Service Bulletin

Reinforcement Plate Installation on aircraft SB-ASTM-CTLS-14

Installation of Reinforcement Plate in upper attachment points of 4-point Harnesses.

SB-ASTM-CTLS-14 , Revision 00

Fig. 3-3-2-1.

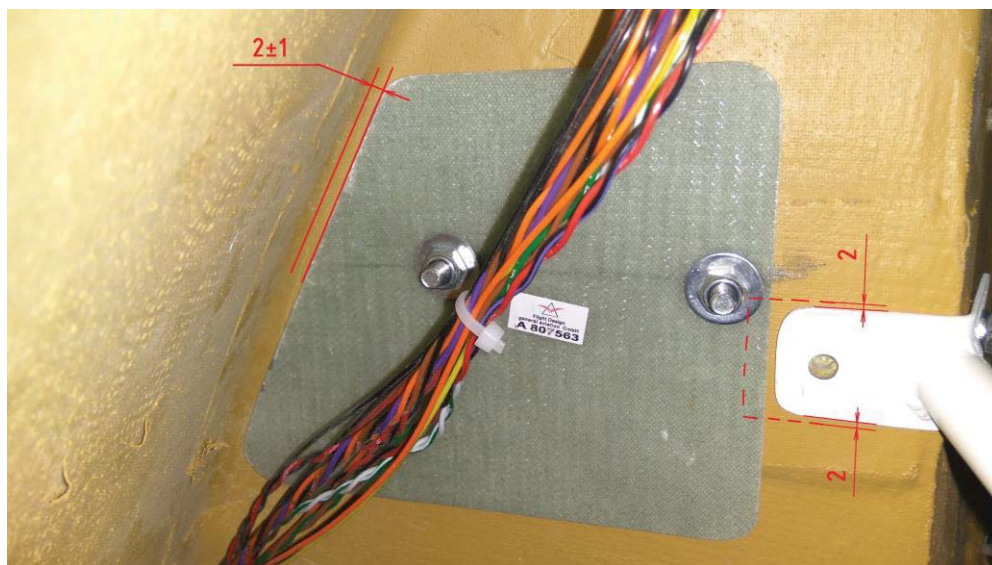
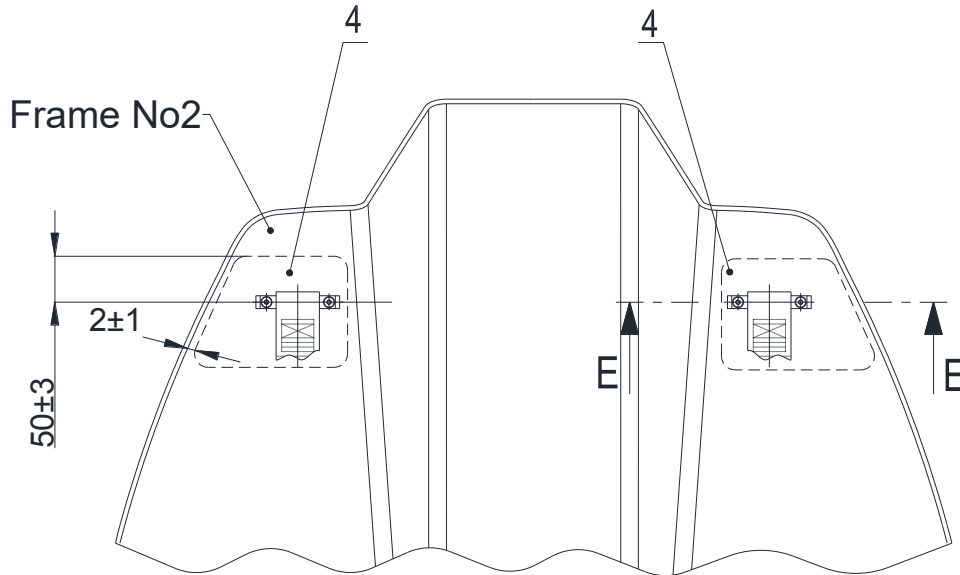
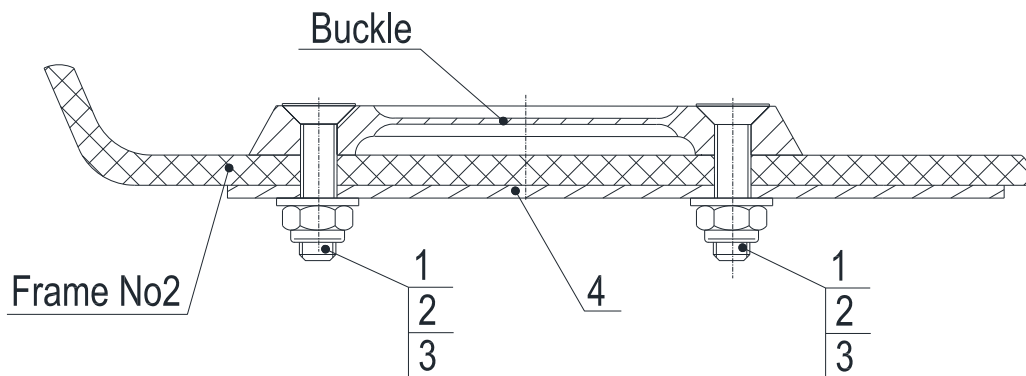
1. Position the plates according to the sketch on the frame. Mark the hole position. In case the plate overlaps with the parachute rescue system bracket attachment, mark and cut out a notch or trim the plate to give the correct placement. See Fig. 3-3-2-1.
2. Drill the 6 mm holes according to the markings.
3. Make a test installation and verify that the plate has correct position and a minimized gap to the frame.
4. Make final installation according to the Sketch 1.

Fig. 3-3-3

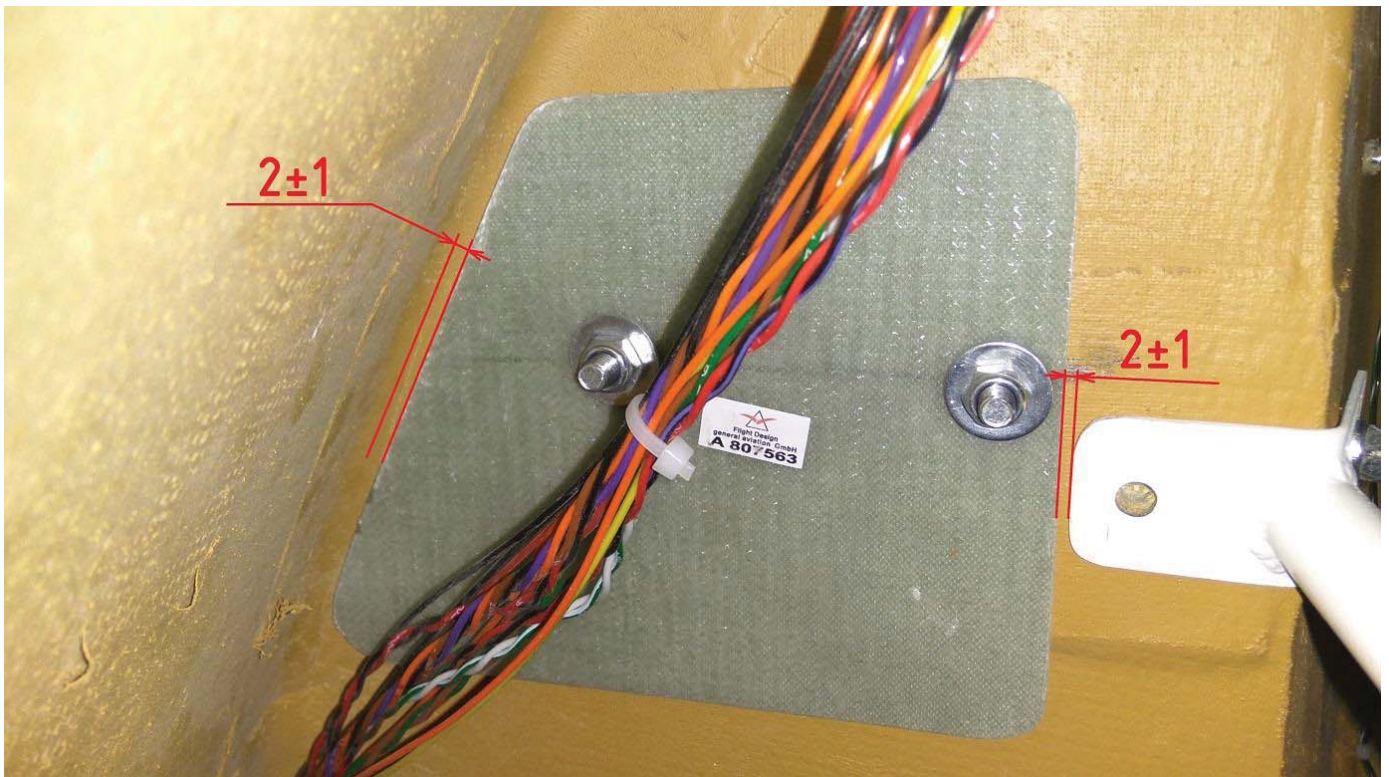
1 - Screw, countersunk DIN7991 M6x30-10.9-IH4-(A2K) - 4 pcs.

2 - Washer DIN 9021-6.4mm VZ - 4 pcs.

3 - Self-locking nut DIN 985-M6, regular - 4 pcs.

4 - Reinforcement Plate - 2 pcs.

Mark all bolt-nut connections with "Paint Maraflor TK 36 red" or equivalent torque stripe.

Tightening torque nuts: 9Nm.
